ZONING CHANGE REVIEW SHEET

CASE: C814-89-0003.02 – 305 S. Congress PUD DISTRICT: 9

TO: PUD-NP, to change conditions of zoning

ADDRESS: 305 S. Congress Avenue

WG Amendment #14

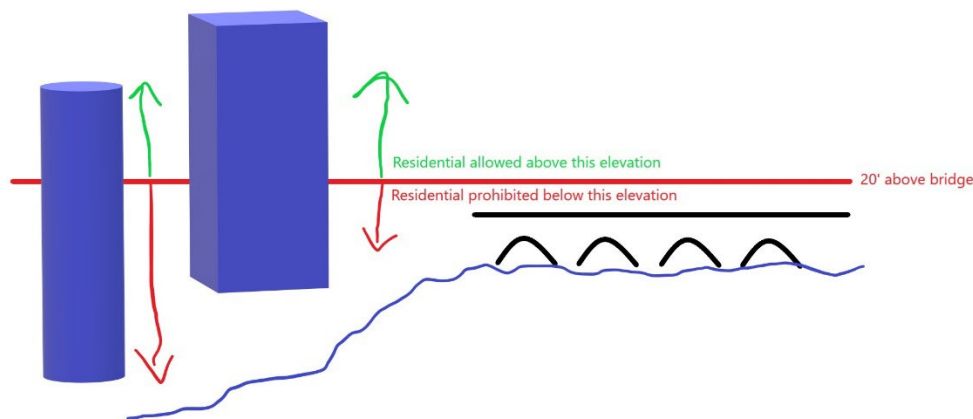
- 5) Please provide a schematic to explain this setback amendment. It is difficult to visualize the phrase “below 20’ above the elevation of the Congress Ave. bridge pavement.”
